Reconnecting Fairview: May 2026 MOA Check-Ins

1.2 Detailed Notes: Meeting #1 – MOA Traffic, PM&E, Parks & Rec

1.3 Detailed Notes: Meeting #2 – AMATS, People Mover, AKDOT&PF

1.4 Detailed Notes: Meeting #3 – MOA Planning and ACDA

Taylor's elevation at the northern section: (Karluk has much softer grades)

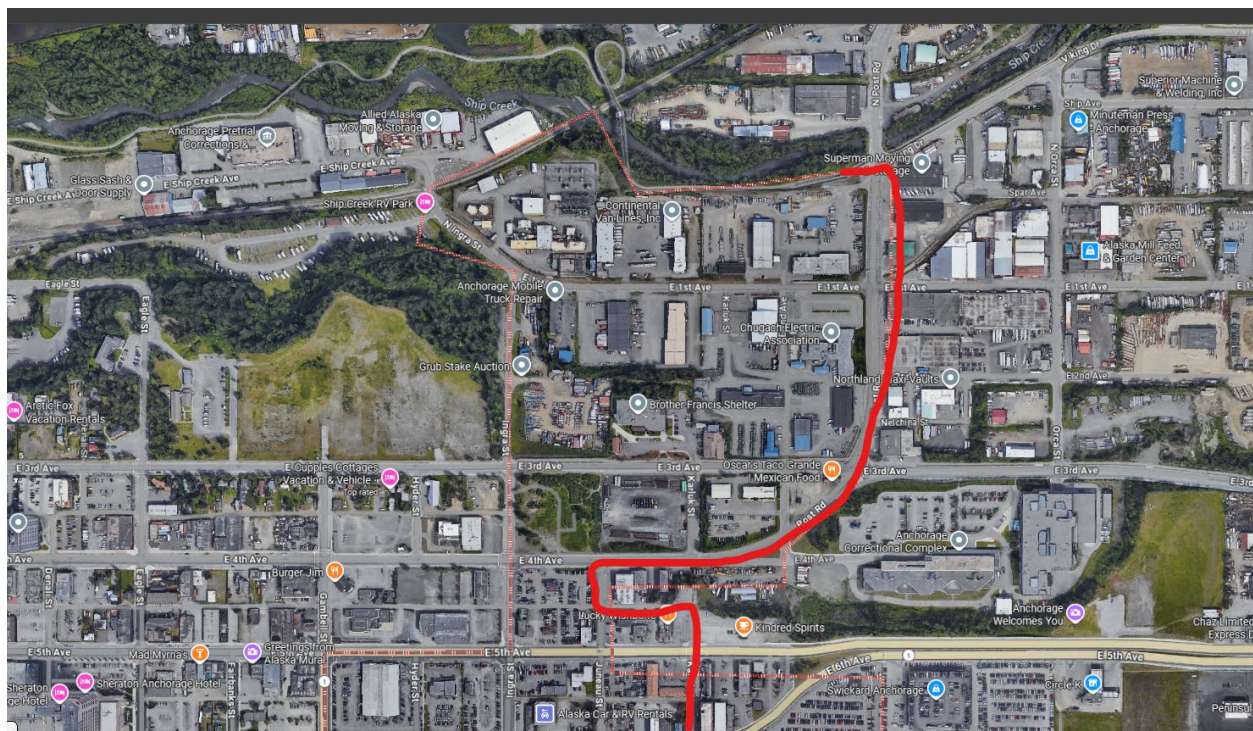
- Brandon noted that ongoing diagnostic study analysis may remove some at-grade rail crossings, limiting connection options. Brad identified steep grades along Eagle Street as a constraint.
- **Implications:** A bridge connection may be required for a direct route. Alternative routes may be more feasible but less direct.

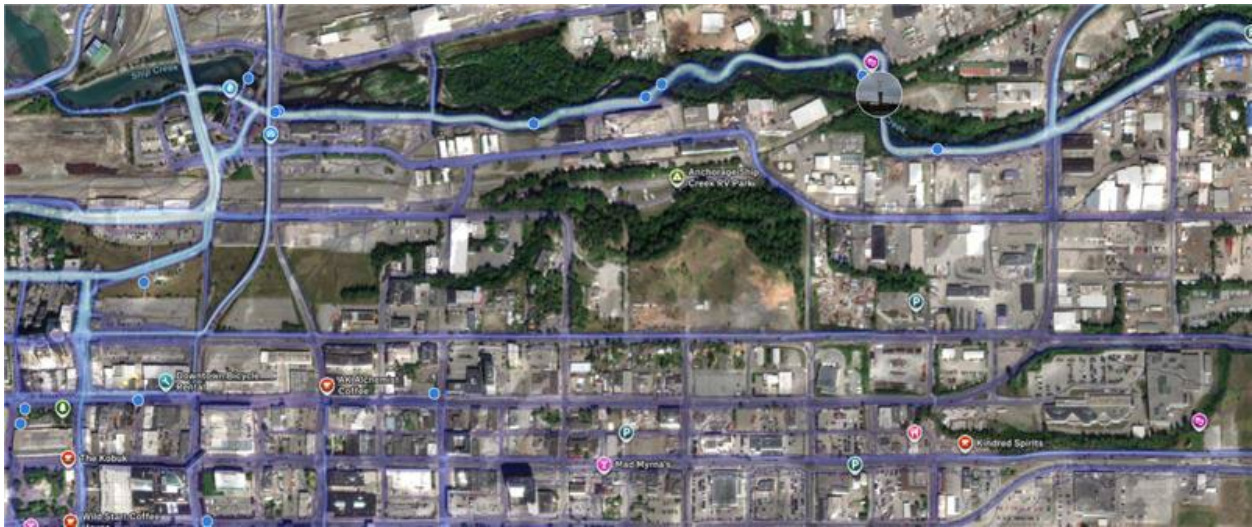
This is how I currently get to the Ship Creek trail from Fairview. Not sure it would work well going both directions (i.e. works better down hill then uphill), but I do very much appreciate the signalized crossing at Karluk to get north of 5th Ave.
